Item No: 6.	Classification: Open	Date: 1 December 2020	Meeting Name: Planning Committee
Report title:		Addendum report: Late observations and further information	
Ward(s) or groups affected:		Borough and Bankside Old Kent Road	
From:		Director of Planning

Item 6.1: 20/AP/1009 - 25 LAVINGTON STREET, SOUTHWARK, LONDON, SE1 0NA.

Item 6.2 – 19/AP/7610 – 14-22 OSSORY ROAD, SE1 5AN

Development too high

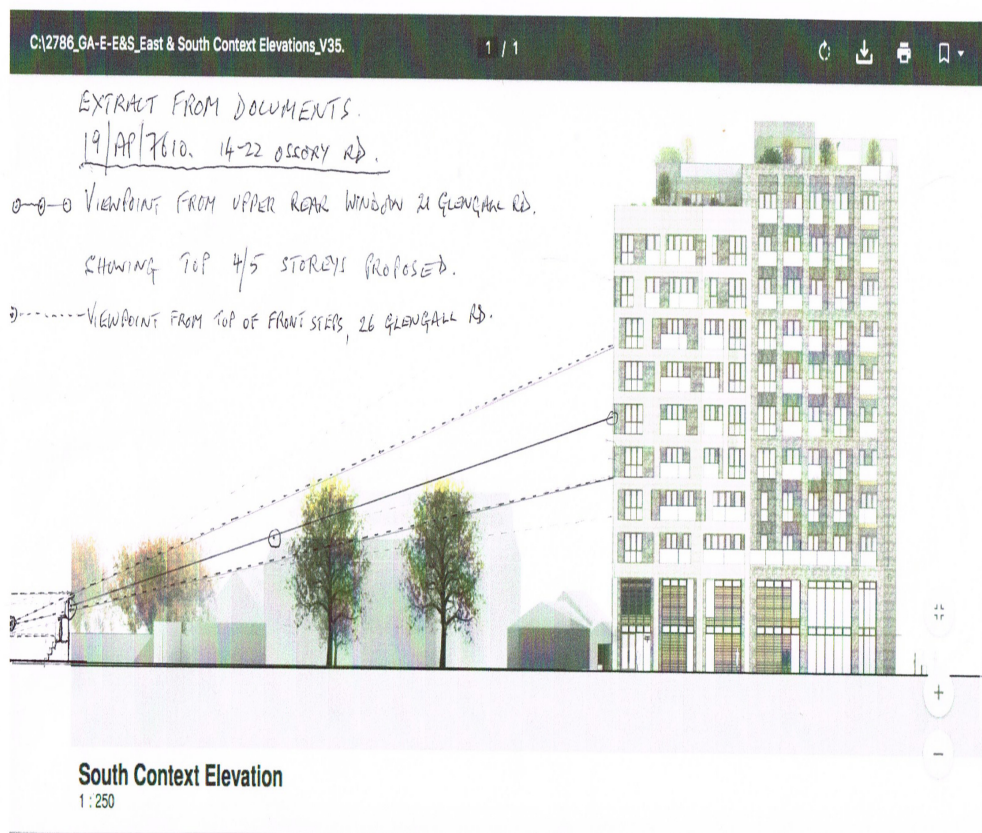
25. I have further studied the Documents. The Officers Report page 44, Viewpoint 2, grossly misrepresents and underestimates the impact of the height of the proposal, from the viewpoint of the Residents of Glengall Rd. From the mid-street, pavement view outside No. 30, the proposed development is FOUR times the height of the houses in Glengall Road. From the upper rear window of 21 Glengall Rd, the height of the proposed development is THREE times the height of the Mineral Water building. The proposed development at 14-22 Ossory Road should be reduced by FIVE storeys. I have recent photographs, more useful to the Planning Committee, to submit.
